CONTRACT CHANGE ORDER NO. \_\_\_\_\_  
SHEET \_\_\_\_ OF \_\_\_\_

**SAN FRANCISCO OAKLAND BAY BRIDGE  
EAST SPAN SEISMIC SAFETY PROJECT**

**SKYWAY CLEANUP ITEMS  
BIKEPATH RAILING SHIMS**

**SKYWAY CLEANUP ITEMS MODIFIED BIKEPATH RAILING DETAILS NO. 1**

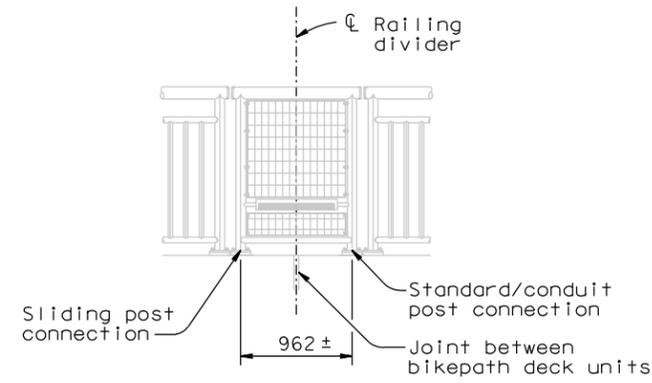
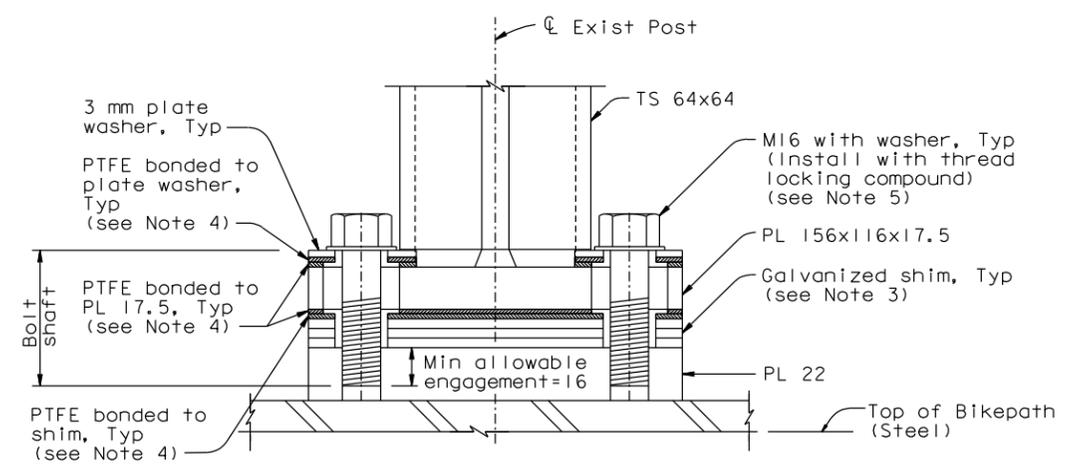
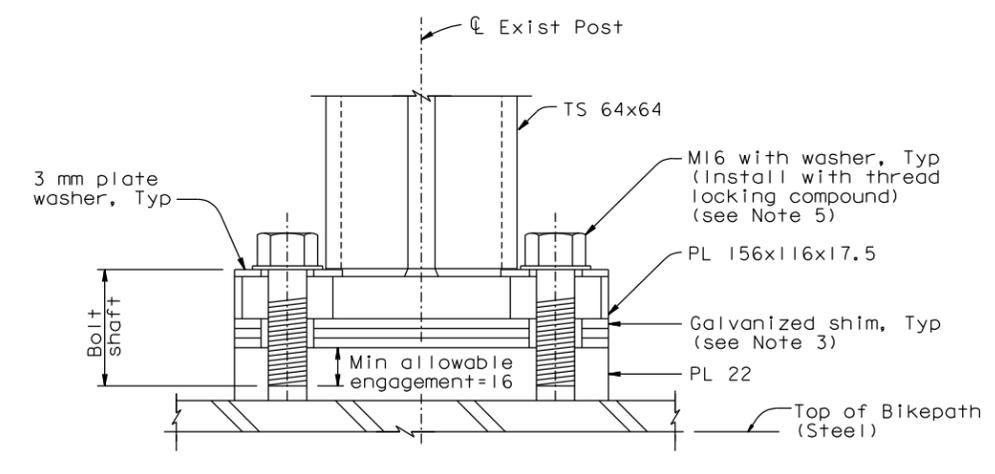
**RECOMMENDED BOLT ALIGNMENT PROCEDURE:**

1. Install sliding post with the bolts centered in the slots. Use sliding plate washer.
2. Install standard/conduit post.
3. If the bolt in the standard/conduit post is located in the center or to the inside (toward the post) of the slot, then use the inner plate washer.
4. If the bolt in the standard/conduit post is located in the center or to the outside (away from the post) of the slot, then use the outer plate washer.

2. Sliding post shall be installed with the bolts centered in the slots ( $\pm 3$  mm).
3. The Contractor may use shims as necessary to align top rail of bikepath railing. One shim may be tapered.

5. All M16 bolts shall be new. Bolts on sliding post shall be tightened to snug tight. Bolts on standard/conduit posts shall be tightened to snug tight plus  $1/4$  turn.

MARK	DATE	DESCRIPTIONS	BY	CH'D	CCO#
△	12/16/11	SKYWAY DIVIDER RAIL MODIFICATIONS	R1	JD	219
△	11/04/11	SKYWAY DIVIDER RAIL MODIFICATIONS	R1	JD	219

**SAN FRANCISCO OAKLAND BAY BRIDGE EAST SPAN SEISMIC SAFETY PROJECT**  
**SKYWAY CLEANUP ITEMS**  
**MODIFIED BIKEPATH RAILING DETAILS NO. 2**

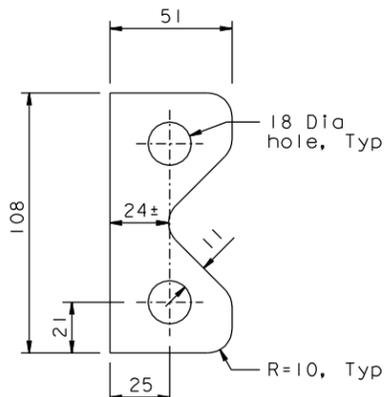
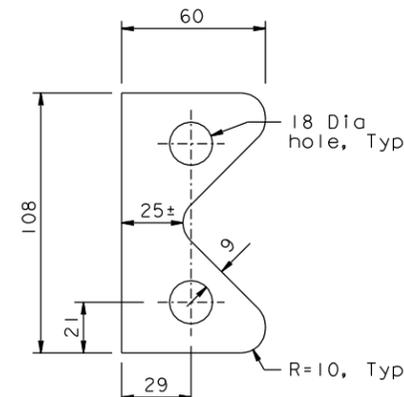
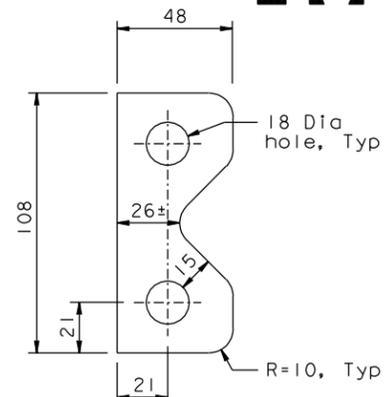
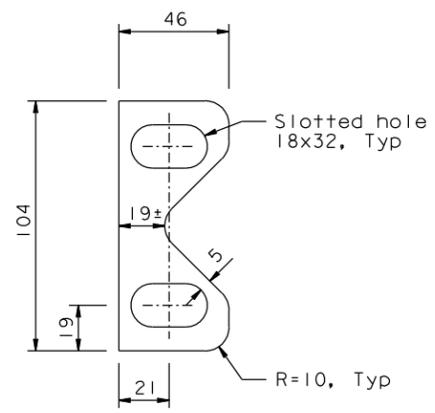
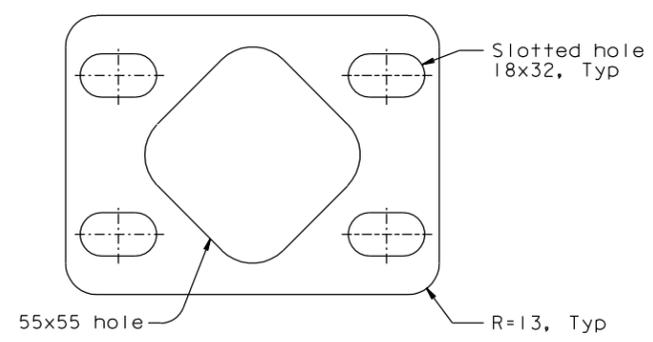
1. Washer plate shall be ASTM A709 Grade 345, galvanized.
2. 55x55 hole required at standard/conduit post only.
3. PTFE at sliding plate washer shall match sliding plate washer dimensions.
4. PTFE at bottom of base plate shall match bottom of base plate dimensions.
5. PTFE at shim shall match shim dimensions.

MARK	DATE	DESCRIPTIONS	BY	CH'D	CCO#
△	12/16/11	SKYWAY DIVIDER RAIL MODIFICATIONS	R1	JD	219
△	11/04/11	SKYWAY DIVIDER RAIL MODIFICATIONS	R1	JD	219
